Product change notification (PCN)

Title / short description	Valve Connectors Type A - Change of the protection circuit from Zener-diode to Suppressor-diode
Affected article category	Cables and lines
Change category	Function, Characteristics, Marking
Change number	CBF240004-01
Reason for PCN/PDN Revision	Update EOP date

SAC Valve Connectors and Adapters Type A

Change of the protection circuit from Zener- to Suppressor-diode

Change of the circuit diagram

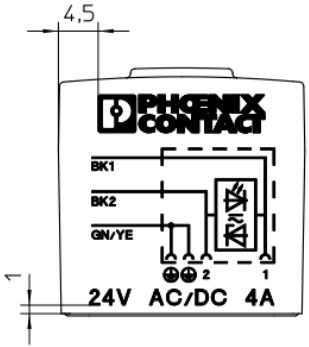
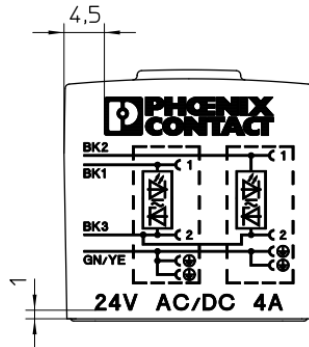
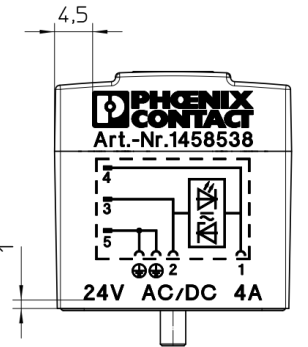
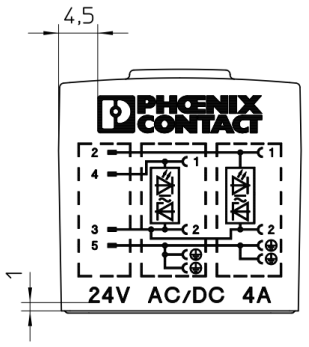
Product Family	SAC Valve Connector Cable	SAC Double Valve Connector Cable	SAC Valve Adapter	SAC Double Valve Adapter
Current diagram				
Future diagram

Electrical property	Pulse power	Terminal voltage	Reverse voltage
Current Z-Diode	40 W (bei 100 µs impulse)	70 V (bei 2 mA constant current)	50 V
Future Suppressor-Diode	600 W (bei 10/1000 µs impulse)	77 V (bei 7,8 A constand current)	min. 53,2 V (at 1 mA constant current)
